INITIAL FIRE SAFETY INSPECTION REPORT

Dekko Washing Ltd

RSC ID: 25881

Date: 10-March-2025

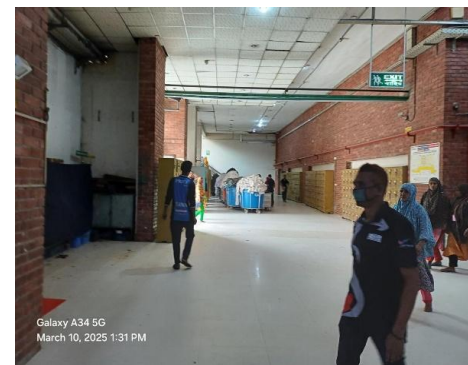
SI No.	Category	Findings	Required Action	Remediation Time Frame
F-1	Fire Rated Construction	Areas used for in-process storage of combustible materials are open to the surrounding occupancy. Location: 1st Floor Washing Building.	Provide defined storage areas and limit the storage arrangement as follows: Maximum height of 2.45 m and maximum area of 23 m² and is separated by a minimum 3.0 m (10ft) from other storage areas and they do not exceed 10 percent of the building area of the story in which they occur. or, If sprinkler protected, Maximum height 12 ft (3.66 m) and maximum area of 1000 ft² (93 m²) and separated by a at least 25 ft (7.62 m) and does not constitute more than 10 percent of the building area or 4000 ft² (372 m²) of the sprinklered area, whichever is greater. or, Enclose the storage area from the surrounding occupancy with a minimum 1 hour construction.	Within 3 months

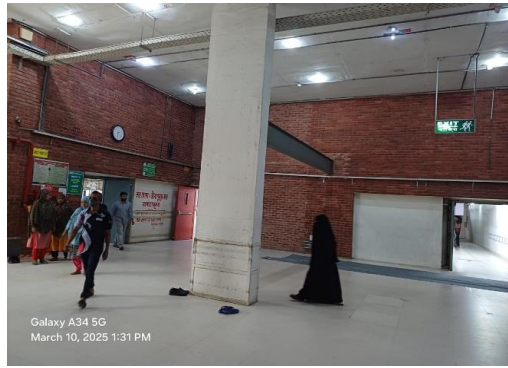
F-2	Means of Egress	The exit stairs are not separated from other occupancy due to non-functional fire doors. Fire doors are not interfaced with fire alarm control panel. Doors was found open with external object. Location: Washing Building	The exit stair enclosure shall be provided with a minimum 1-hr fire resistance rating for buildings with 3 or fewer stories and a minimum of 2- hr. fire resistance rating for buildings 4 or more stories. Provide 0.75 hr. fire rated door and seal all penetrations and openings by 1 hr. fire rated fire rated barrier construction for building with 3 or fewer stories. Provide 1.5 hr. fire rated door and seal all penetrations and openings by 2 hr. fire rated fire rated barrier construction for building with 4 or more stories. Ensure that the fire doors are self-closing and positive latching and that they are provided with fire exit (panic) hardware where serving production floors. If fire doors are required to be held open for functional reasons, provide automatic closing devices tied to the fire alarm system.	Within 3 months

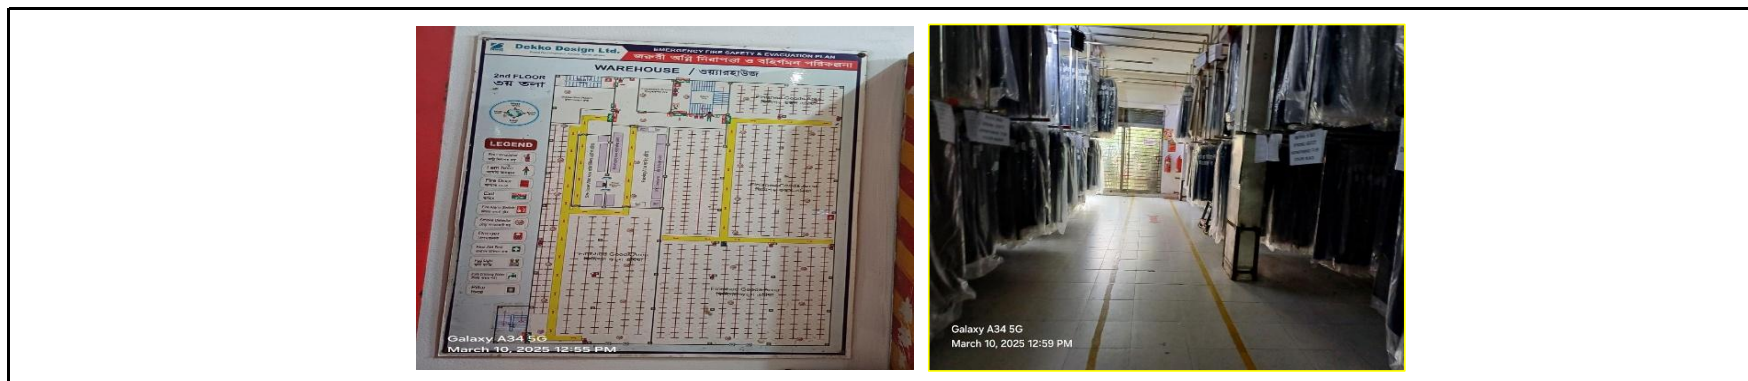
F-4	Means of Egress	North exit discharge path of Washing building was not separated from CNG Shed & Boiler Shed. Location: Washing Building	Seal all penetrations and openings to the interior of the building along the discharge path, up to a height of 10 ft. to provide a minimum 1-hr fire separation. Alternatively, provide a second remote discharge path to the public way (only include this if feasible).	Within 3 months

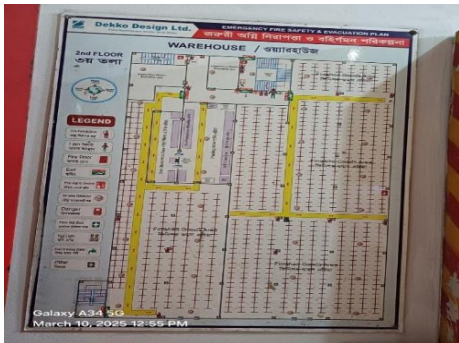
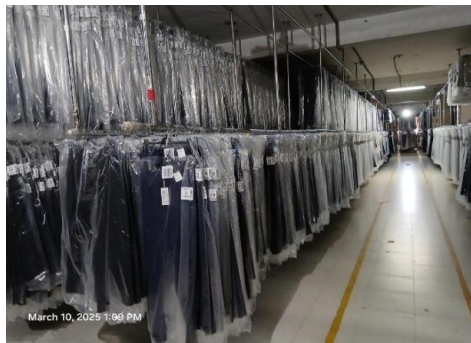
F-5	Mean of Egress	Storage areas discharges directly into the exit stair enclosure. Location: 2nd floor, Washing Building	Openings from exit enclosure to Storage areas/ basements/ transformer rooms/ generator rooms/ boiler rooms and similar normally unoccupied spaces shall be provided with a vestibule with fire rated construction and openings in accordance with section 6.14.3 of RSC Technical Guidelines (Standard)¹ V1.0. . Provide a 1.5 hr. fire rated door on the exit stair side and a 1-hr. fire rated door on the Store, generator, sub-station room side . Ensure that the fire rating of the vestibule construction matches that of the exit stair enclosure as per RSC Technical Guidelines (Standard)¹ V1.0. section 6.14.3. The minimum width for vestibules shall not be less than 1.1m and length 1.8m.	Within 3 months

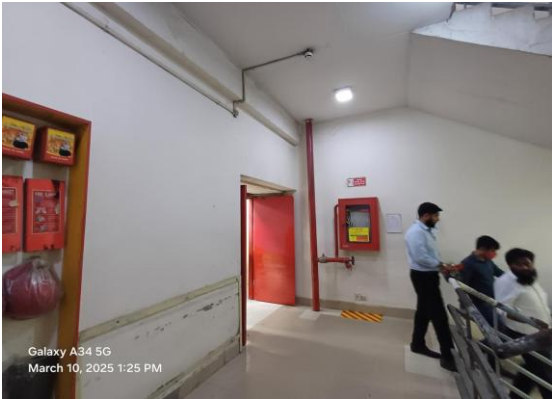
F-6	Mean of Egress	Stair-1 terminates the occupants in interior building exit discharge, which is not in accordance with section 6.17 of RSC Technical Guidelines (Standard)¹ V1.0. Location: Ground floor, Washing Building.	1. Modify stair to discharge directly outside. Or 2. A maximum of 50 percent of the number and capacity of the exit enclosures can discharge through areas on the level of exit discharge where all of the following are met: (1) Automatic sprinkler protection is provided throughout the level of exit discharge or portion of the level of discharge where separated from non sprinklered portions of the floor by fire barriers with the same fire resistance rating as the exit enclosure. (2) The interior discharge is not through a storage or hazardous occupancy. (3) The entire area of the level of exit discharge is separated from areas below by construction having a fire resistance rating not less than that required for the exit enclosure. (4) The way to the exterior shall be free and unobstructed and shall be readily visible and identifiable from the point of discharge of the interior exit.	Within 3 months

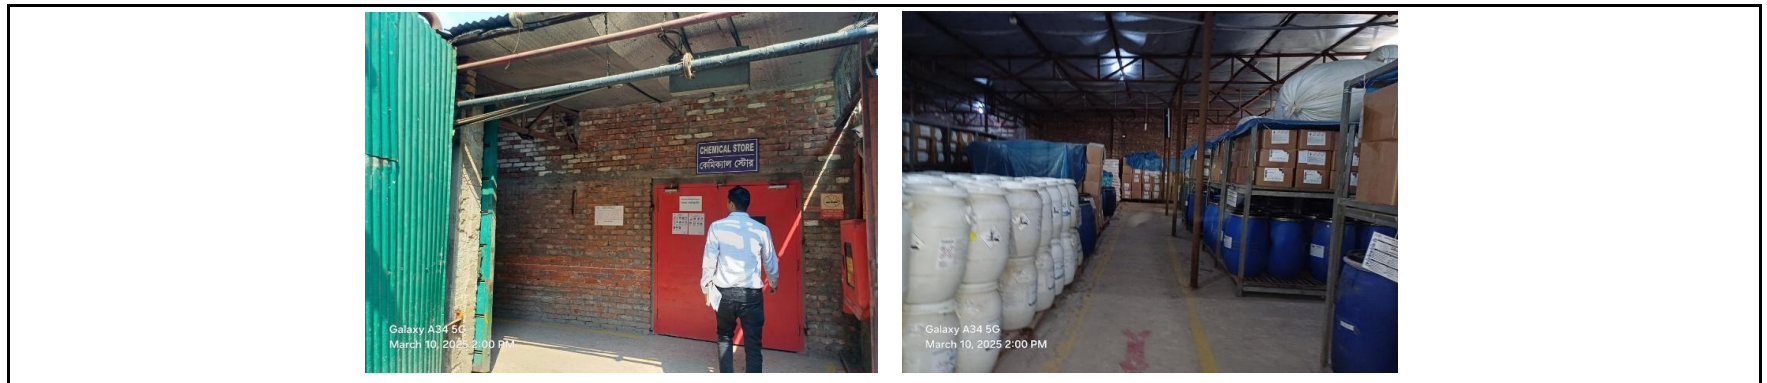
F-9	Mean of Egress	Common path of egress travel exceeds 30 m (100 ft) at Packing/finished goods warehouse. Location: 2nd Floor, Washing Building.	Reconfigure the egress arrangement to reduce the maximum common path of travel to not more than 30 m (100 ft) for Group H (storage) occupancies. The common path of egress travel shall not exceed 23 m (75 ft). Where the building is provided with a complete automatic sprinkler system, the common path of egress travel shall not exceed 30 m (100 ft). The common path of egress travel for Group H (storage) occupancies with not more than 30 occupants shall not exceed 30 m (100 ft). The common path of egress travel for Group J (high hazard). Section 6.13.2 of RSC Technical Guidelines (Standard) shall meet.	within 3 months

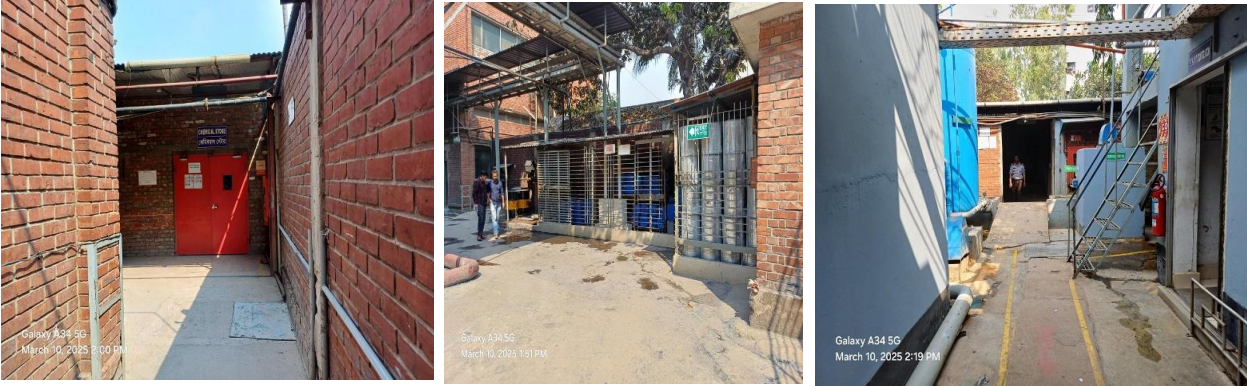
F-13	Means of Egress	Occupant load sign & floor designation sign were found missing at the required locations on all floors. Location: All Buildings & Shed	Provide occupant load sign & floor designation sign at required locations.	Within 1 month

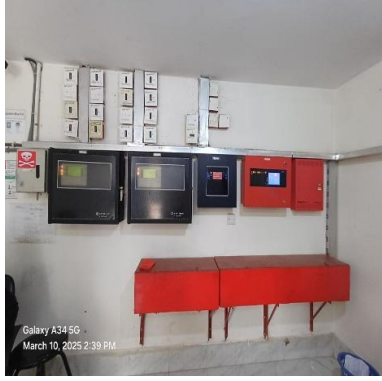
F-15	Fire Rated Construction	The chemical store shed is interim construction, and the main structural element of the shed is constructed by steel which is non-rated and was found in exposed condition without any fire protection. Location: Store shed	Construction of interim non-high-rise buildings containing J occupancies shall be Type 1 construction. So, provide require rating in the structural elements of the building. Consult with a qualified fire protection engineer.	Within 6 months
